M-2004-051 Technical Revision 04 - Wattenberg Lakes Mine

RE: Wattenberg Lakes Aggregate Mining Design Modifications, Weld County, Colorado; U.S Army Corps of Engineers (Corps) File No. NWO-2000-80189-DEN

Wattenberg Lakes Gravel Mining Revised Compensatory Mitigation Plan Weld County, Colorado

Figure 3. Proposed Design Modifications

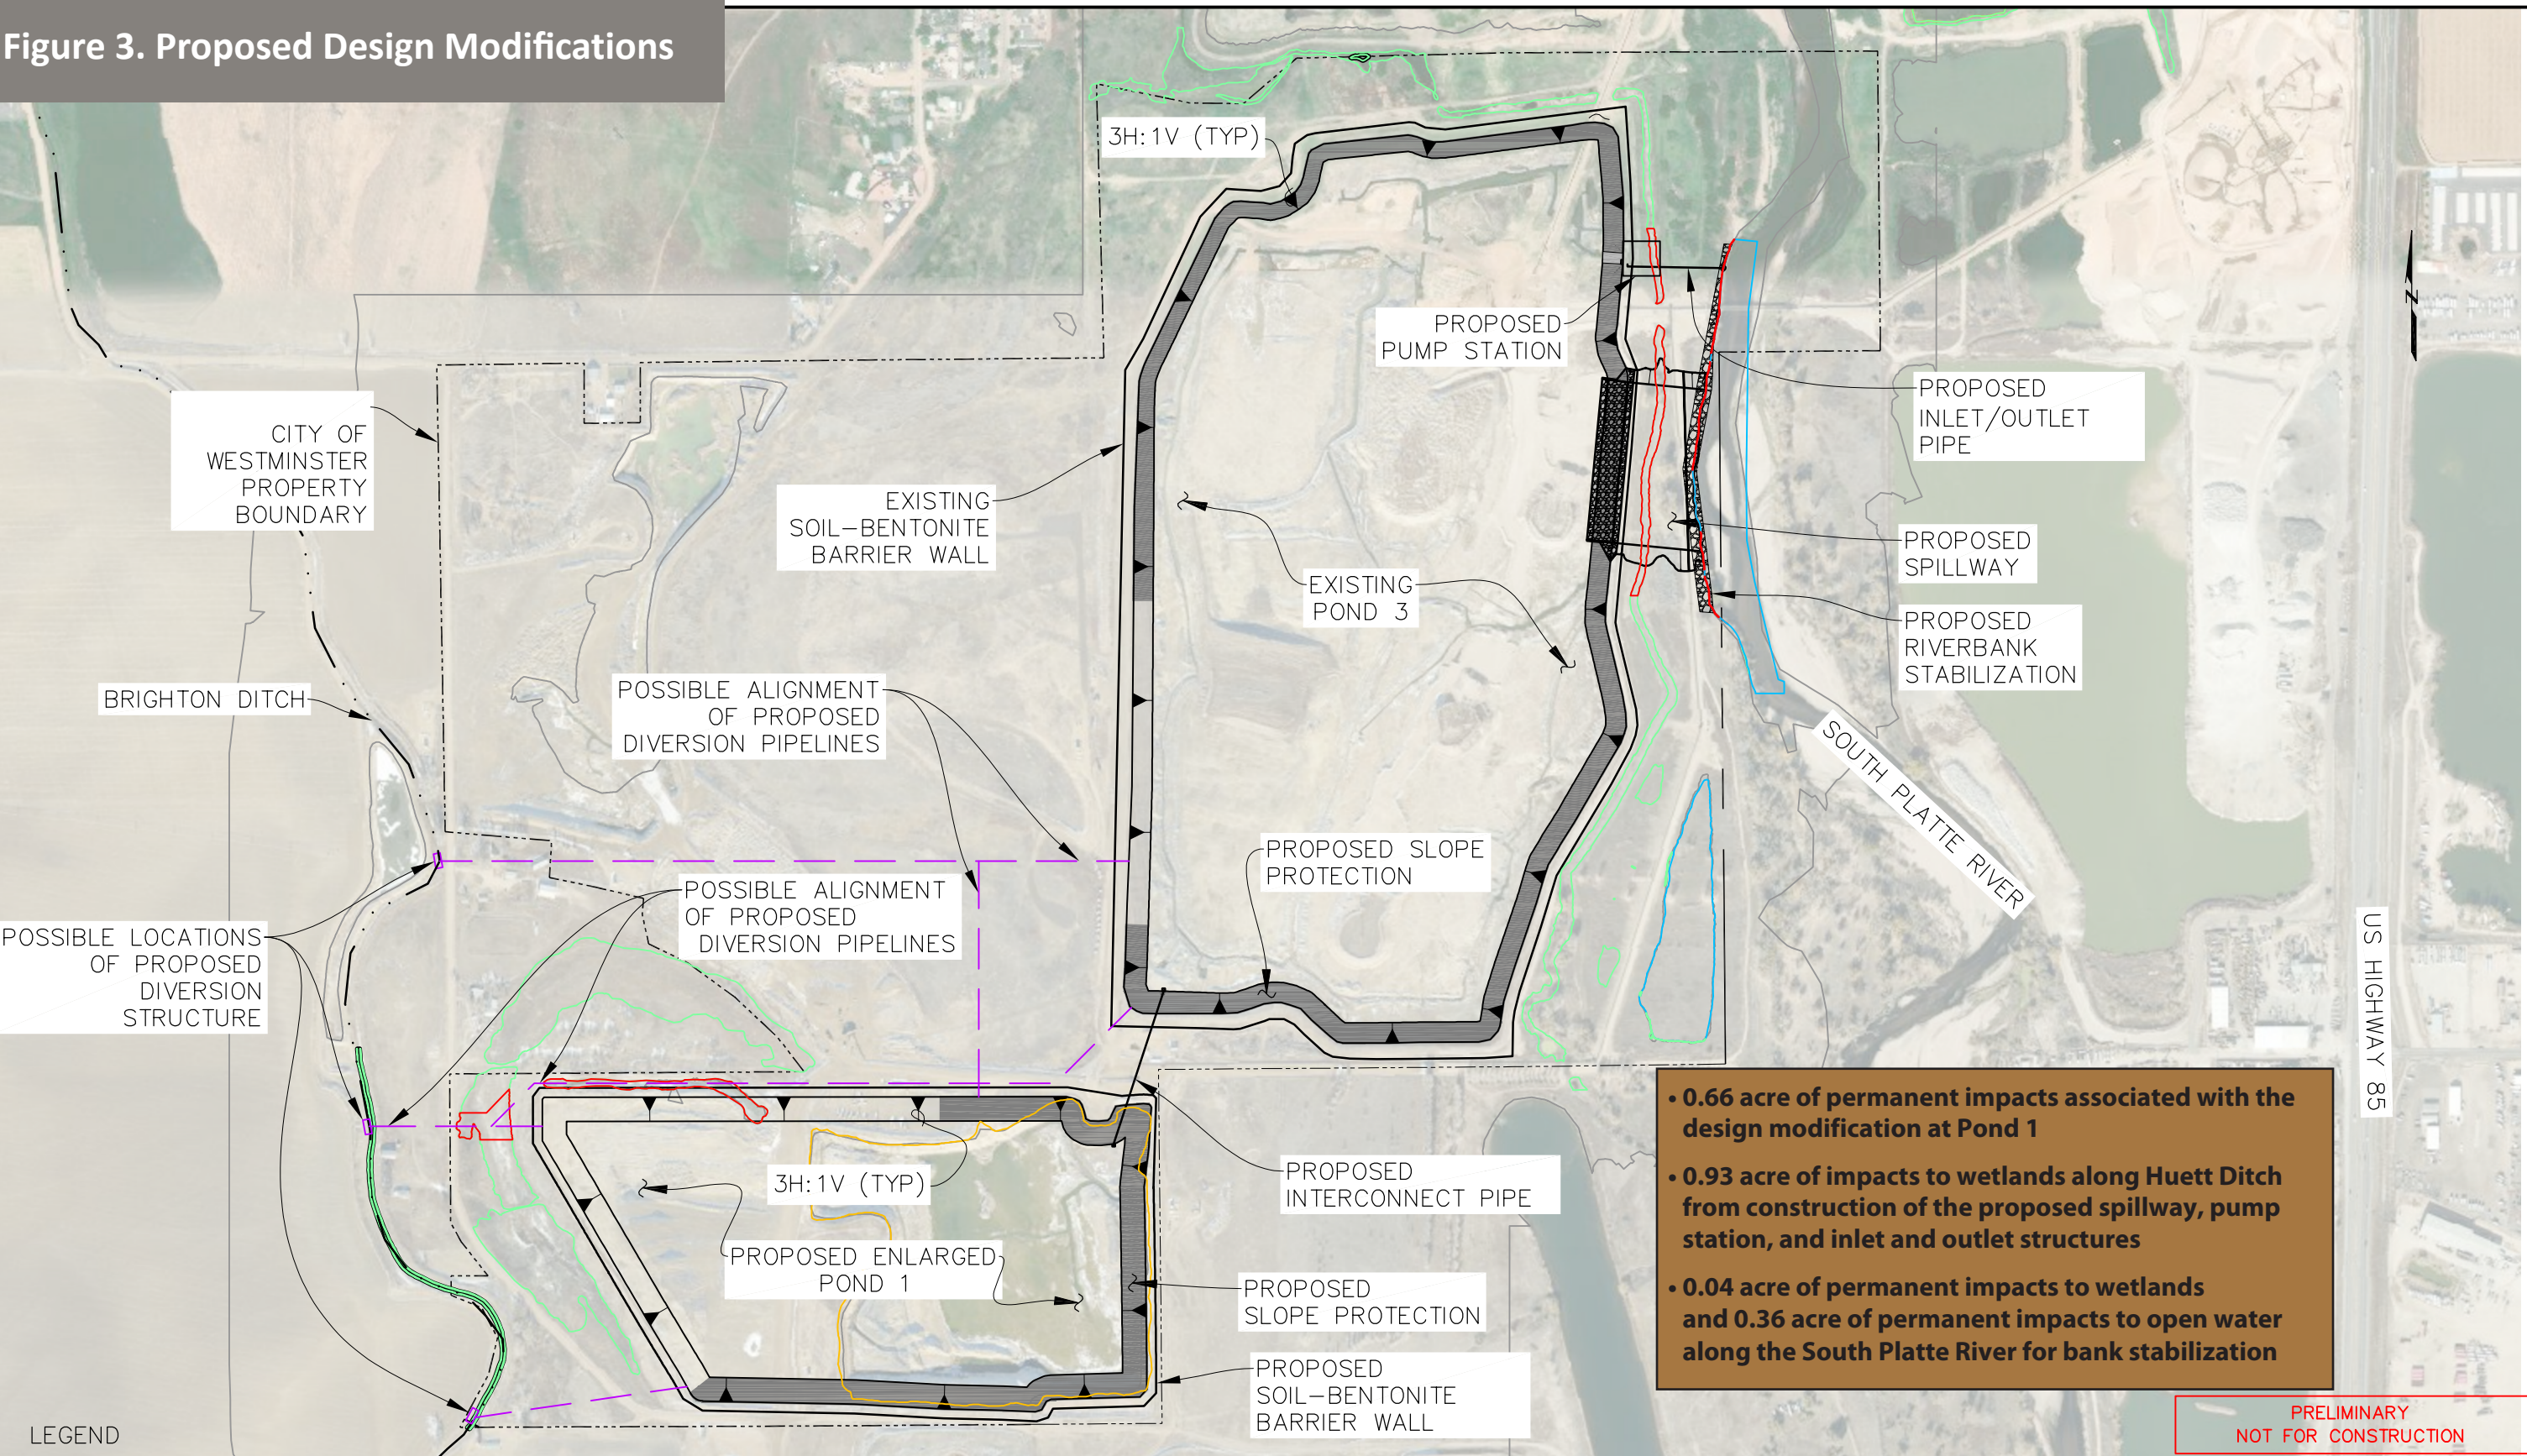
The gravel mining operations have been ongoing since 2005 and occur along both the east and west sides of the South Platte River. The Corps issued a time extension for the project in July 2015, and the permit now expires on July 31, 2023. The original design of the project included construction of three reservoirs on the west side of the South Platte River post-mining operations (Figure 2). The City is proposing modifications to the project design, including changing the number of reservoirs from three to two, and installation of a spillway at Pond 3 to prevent damage from flood events along the river (Figure 3). ERO conducted a thorough assessment of the current project impacts on wetlands and waters of the U.S. and the proposed impacts based on the proposed project modifications. Details of the proposed project modifications are discussed below and shown on Figure 3 and Appendix A.

Construction of the pump station and inlet and outlet structures that were included in the original IP may occur at a later stage than construction of the spillway and bank stabilization (Figure 3). The design modifications associated with the spillway and bank stabilization would result in an additional 0.93 acre of temporary impacts on wetlands along Huett Ditch and approximately 0.04 acre of wetlands and 0.36 acre of stream channel along the west bank of the South Platte River. The proposed activity would result in an average of approximately 0.22 cubic yards per running foot of fill placed below the Ordinary High Water Mark.

Figure 4
Mitigation Plan

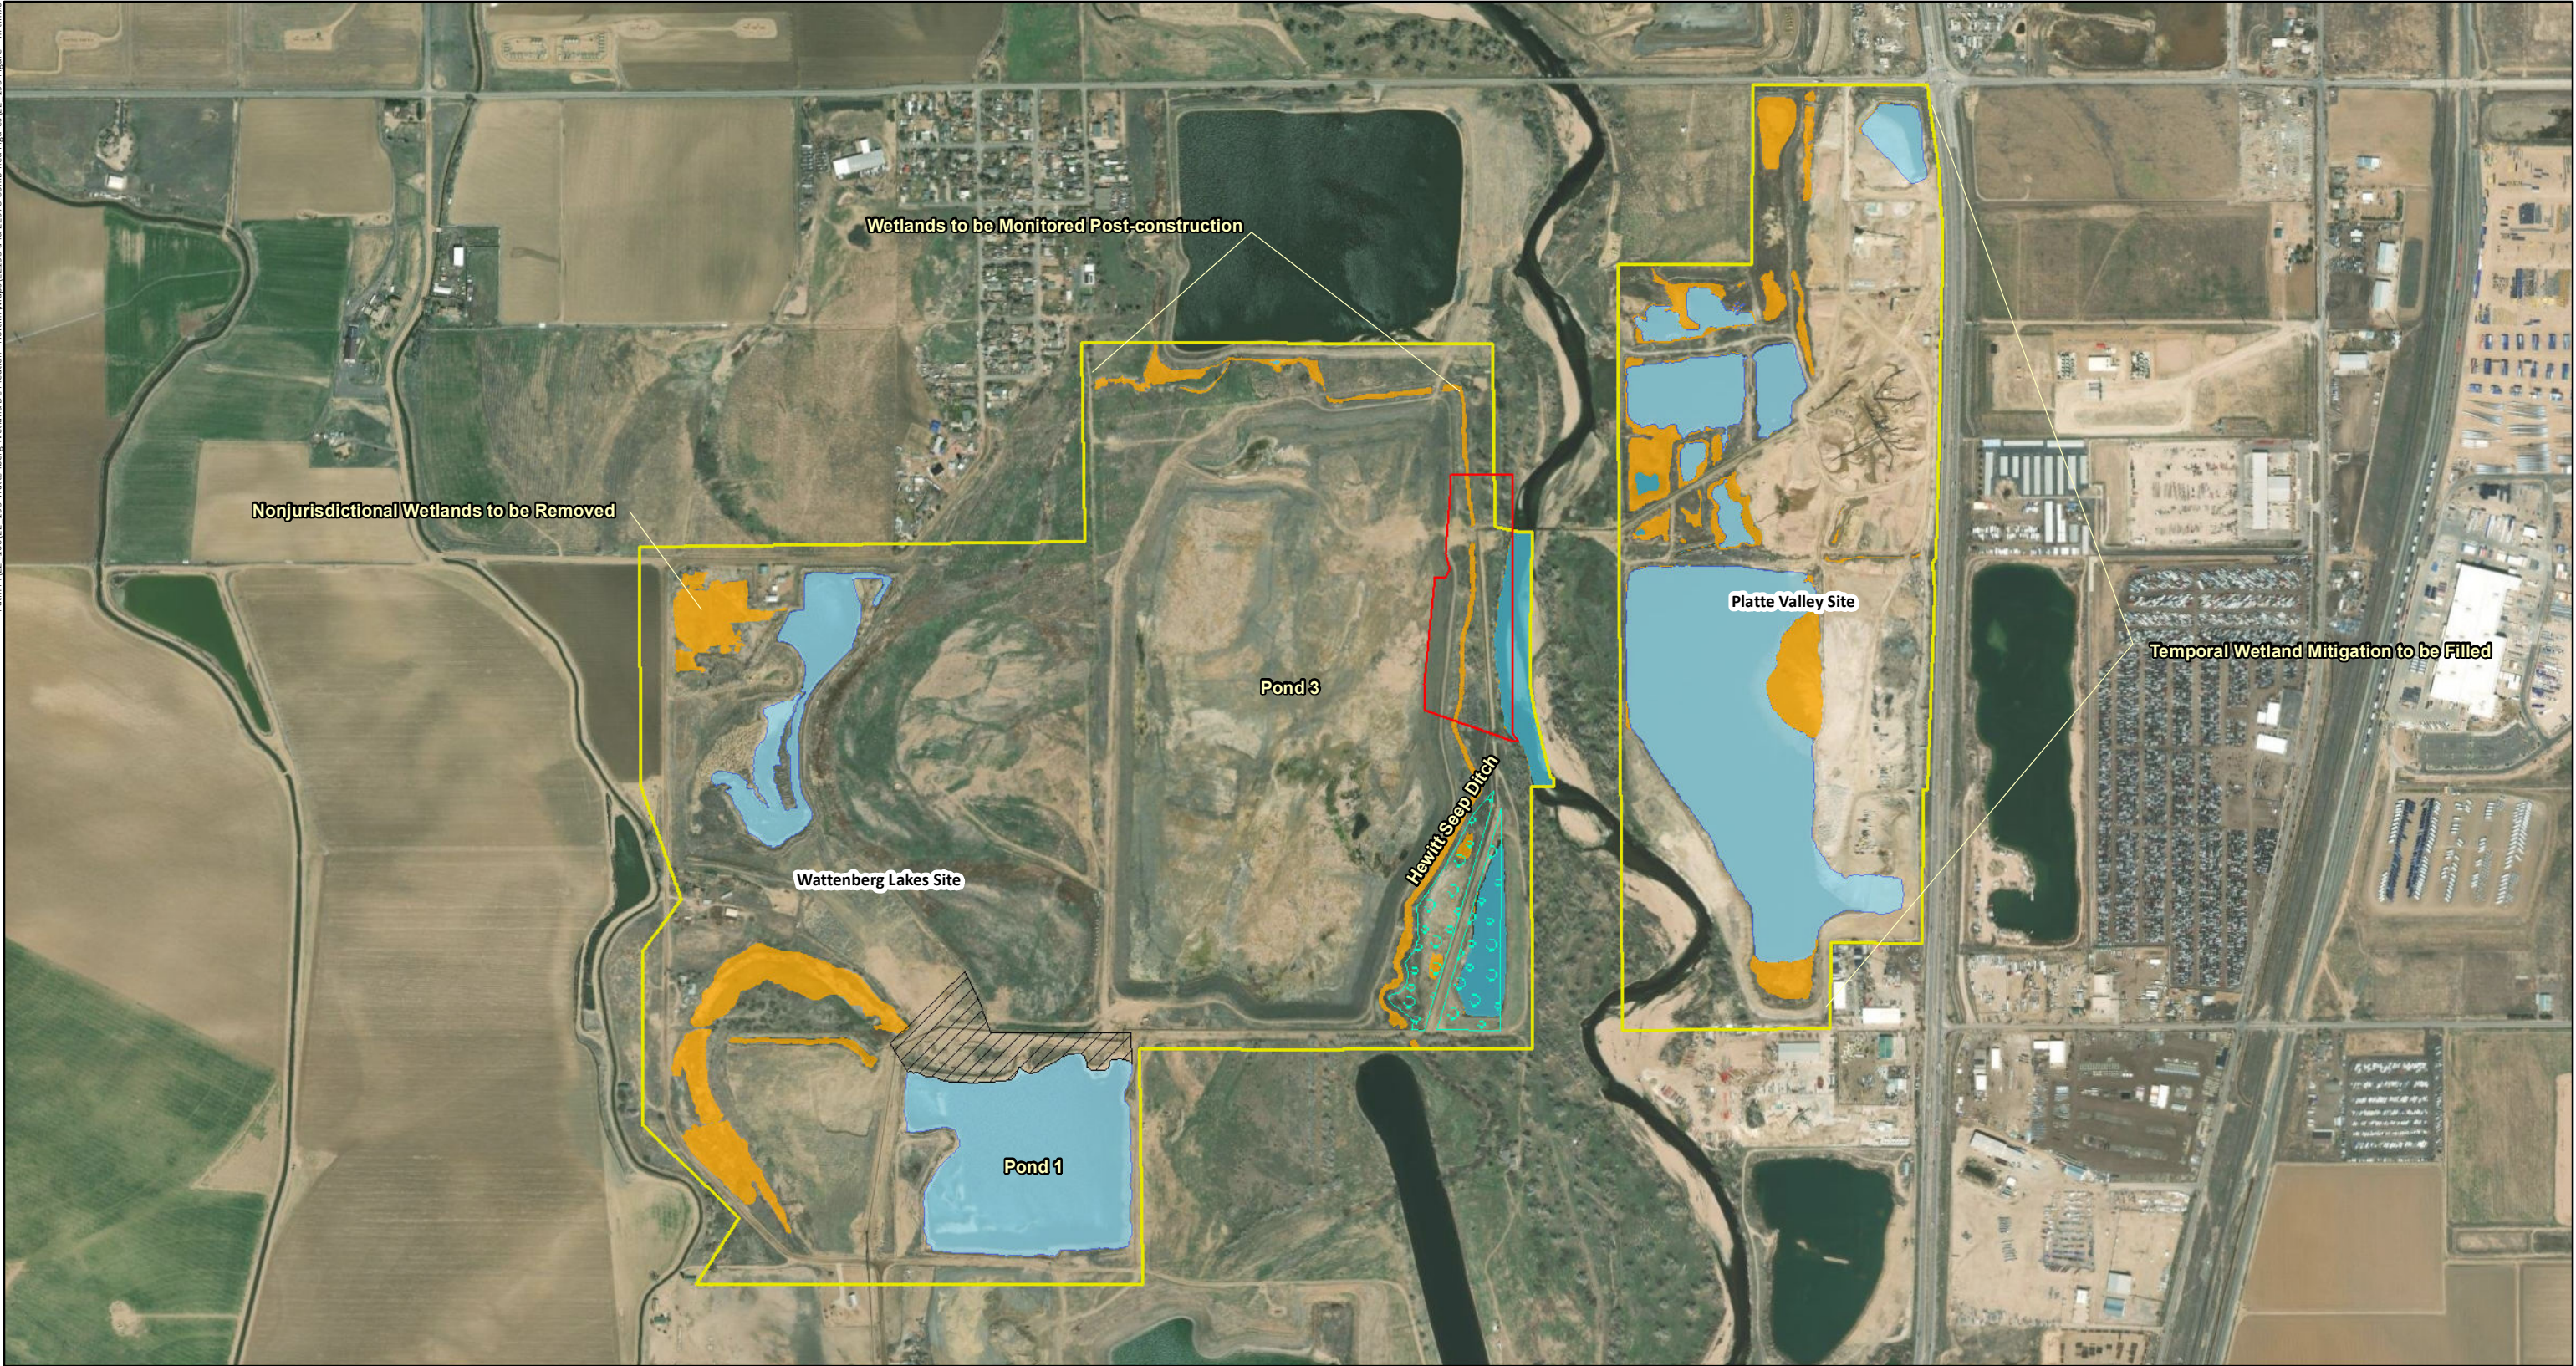
Due to these modifications to the design, and to provide the highest quality wetland mitigation, Holcim is proposing modifications to the wetland mitigation required by the project (Appendix B). Wetland mitigation for the project is proposed at an aerial and functional compensatory mitigation ratio of 1.25:1 for the original project impacts and a ratio of 1:1 for the additional impacts from the proposed design modifications. The overall impacts on wetlands for the project including the original IP impacts, additional impacts, proposed modifications, total 35.61 acres. When applying the mitigation ratios, Holcim is proposing 44.00 acres of wetland mitigation (Table 2). Mitigation associated with Huett Ditch has already occurred onsite, resulting in the successful reestablishment of 2.34 acres in a wetland channel. When accounting for the 2.34 acres of wetlands that have been restored onsite, 41.63 acres of wetland mitigation remains to compensate for project impacts (Table 2), for which Holcim is proposing to purchase 41.63 acres of mitigation bank credits from the Corps-approved South Platte Mitigation Bank in Morgan County. The project area is within the primary service area of the South Platte Mitigation Bank in the Middle South Platte-Cherry Creek subbasin (HUC 10190003).

Proposed Cottonwood Replacement Area to be Eliminated

Proposed Design Modification Area
- 41.62 acres of Wetlands to be Purchased from the South Platte Mitigation Bank
